NOTICE OF DECISION

Case File: T2-2019-12701

Permit: Administrative Decision by the Planning Director, Design Review (DR), and Lot of Record (LOR) Verification

Proposal Summary: The applicant is requesting an Administrative Decision by the Planning Director, Design Review and a Lot of Record verification in order to establish and construct a wireless communications facility (WCF) utilizing concealment technology (the tower will mimic an evergreen pine).

Exhibit A.15 – Site Plan: Sheet No. A-1 and A-1.1

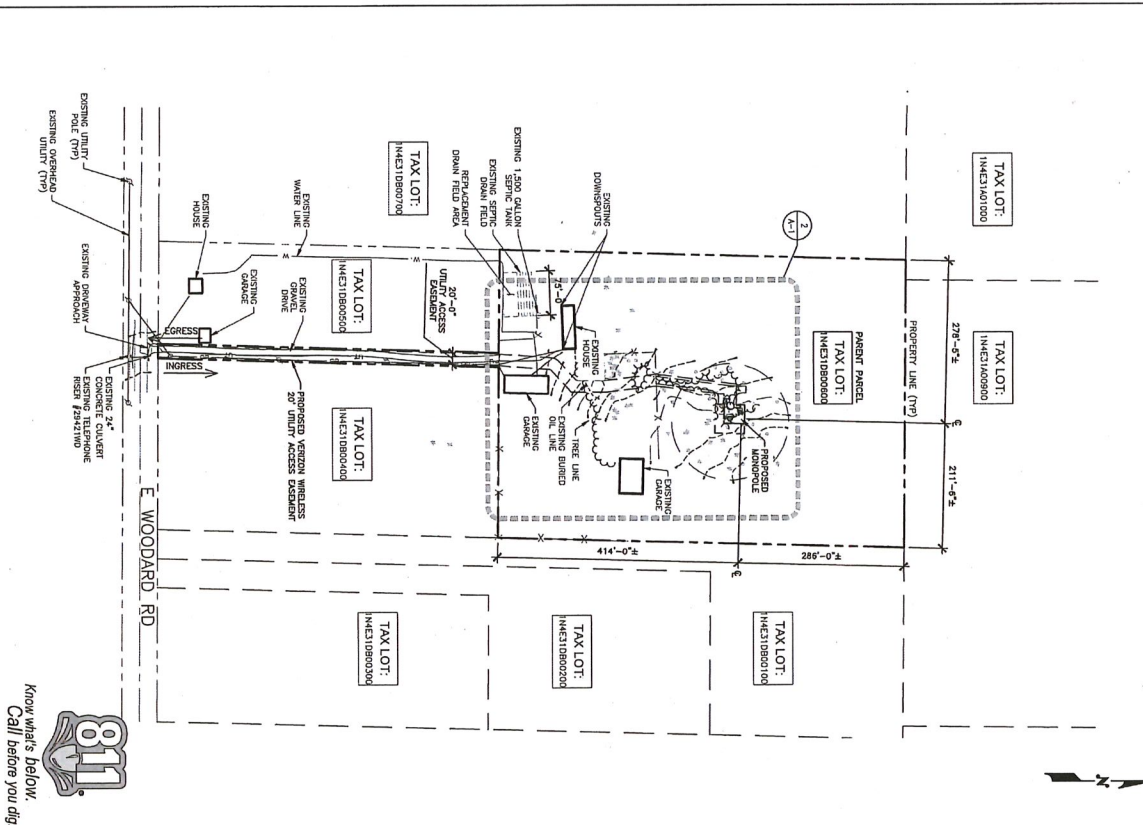
Staff: The applicant has provided a site plan showing the location of the wireless communications facility (WCF). The WCF consist of a cell tower that mimics a pine tree, equipment cabinets, a diesel generator, and fencing (Exhibit A.15 - Sheet No. A-1.1). The yard dimensions are required to ensure that there is sufficient open space between buildings and

Staff: The applicant has provided a site plan showing the location of required parking and yard areas. As shown on the site plan, the parking and yard areas are provided on the same Lot of Record as the development being served (Exhibit A.15 – Site Plan: Sheet No. A-1 and A-1.1). *This criterion is met.*

Staff: As shown on the Site Plan, as Exhibit A.15 – Site Plan: Sheet No. A-1 and A-1.1, the applicant proposes to locate one (1) parking space adjacent to the fenced area of the WCF. As discussed in Section 7.13 and 7.14, the proposal will require one (1) parking space that can also be utilized as a loading space. The minimum parking space dimensions are a minimum width of 9 feet and a length of 18 feet. The parking area adjacent to the fenced area of the WCF is 9 feet by 18 feet, which meets the minimum requirements. *This criterion is met.*

Staff: As shown on the Site Plan, as Exhibit A.15 – Site Plan: Sheet No. A-1 and A-1.1, the applicant proposes to locate one (1) parking space in the area near the WCF fence. The site plan does not indicate that curbs or bumper rails will be installed to delineate areas of parking and maneuvering of vehicles. The proposed location of the parking is separated from E Woodard Road by forested areas. The forest vegetation will prevent unchanneled motor vehicle access/egress; therefore, a bumper rail or curbing is not required to be installed. *These criteria are met.*

Staff: As shown on the Site Plan, as Exhibit A.15 – Site Plan: Sheet No. A-1 and A-1.1, the applicant proposes an extensive drainage plan to ensure that the area is graded and drained for the disposal of surface water on the lot. The applicant has also provided a Storm Water Certificate that indicates that the stormwater system will utilize the natural drainage of the site to ensure that the rate of runoff from the lot for the 10-year/24-hour will be no greater than that before development. The storm water design for the project was reviewed and stamped by Harold Duncanson, Registered Professional Engineer on December 13, 2018 (Exhibit A.36). *This criterion is met.*

Staff: As shown on the Site Plan, as Exhibit A.15 – Site Plan: Sheet No. A-1 and A-1.1, the applicant proposes to locate one (1) parking space in the area near the WCF. The site plan indicates that the parking area connecting the drive to the public street is approximately 981 feet from the front property line Exhibit A.15 – Site Plan: Sheet No. A-1 and A-1.1). The subject property is not located in RC, BRC, SRC, PH-RC, OR and OCI base zones or C-3, LM, or MR-4 base zones so MCC 39.6580(B), (D), and (E) are not applicable. The yard is currently unpaved and contains pasture and trees. *These criteria are met.*

Staff: The site plan indicates that only one ground mount is being proposed for the subject property (Exhibit A.15 – Site Plan: Sheet No. A-1 and A-1.1). *This criterion is met.*

PROPOSED ELEVATION	1
--------------------	---

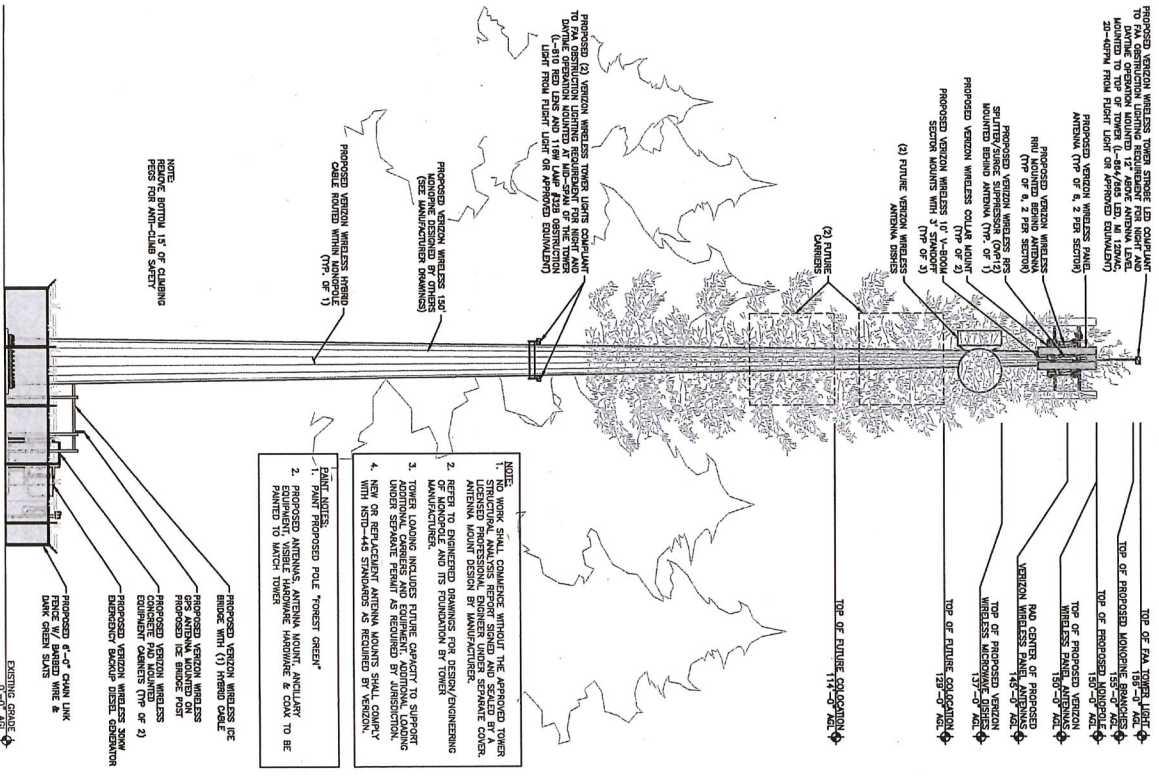
- ii. Architectural drawings, indicating floor plans, sections, and elevations:
 1. Updated elevations shall include the labeling of the paint color of the tower, on-tower components, associated on-ground structures (i.e., vaults and equipment cabinets), and fence. A paint chip or sample shall be provided showing the proposed colors. The colors shall be either green or brown in a non-reflective flat dark earth tone or a non-reflective flat earth tone. [MCC 39.7740(B)(1)(b), MCC 39.7740(B)(5), MCC 39.7740(B)(6), MCC 39.8040(A)(1)(a)]

The applicant has also provided an elevation plan showing the height of all the structures that are part of the wireless communications facility. The top of the ice bridge is approximately 9 feet, the top of the cabinets is approximately 7 feet, and the top of the fence is 6 feet. All of these structures are less than the maximum height of 35 feet (Exhibit A.15 – Sheet No. A-2). As allowed in subsection (E) below and MCC 39.7740(B)(2) the top of the proposed monopine and the attached antennae are allowed to exceed the 35-foot height maximum. The monopine is 155 feet tall. *These criteria are met.*
